ALEXA 35 Software Update Package 6.0.0

ALEXA 35 | ALEXA 35 Xtreme | ALEXA 35 Live | ALEXA 265

RELEASE NOTE

D45 1000 6706 • K11755

Exposure Index Fine Adjustment

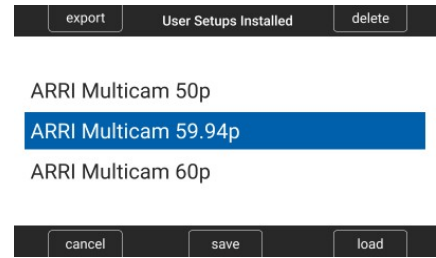
It is often desirable to keep a fixed iris setting to maintain depth of field during live productions. With SUP 6.0.0, the Exposure Index can be finely adjusted from the Remote Control Panel to compensate for changing lighting conditions, allowing precise exposure control without altering the iris and keeping the image consistent.

Multi-State Tally Overlay

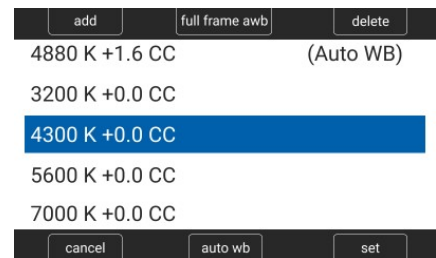
The camera's VF tally overlay now supports displaying red, green, and yellow tally signals simultaneously. This is particularly useful in setups where live video is sent to multiple destinations, each controlled by different directors, allowing camera operators to see all tally states at once.
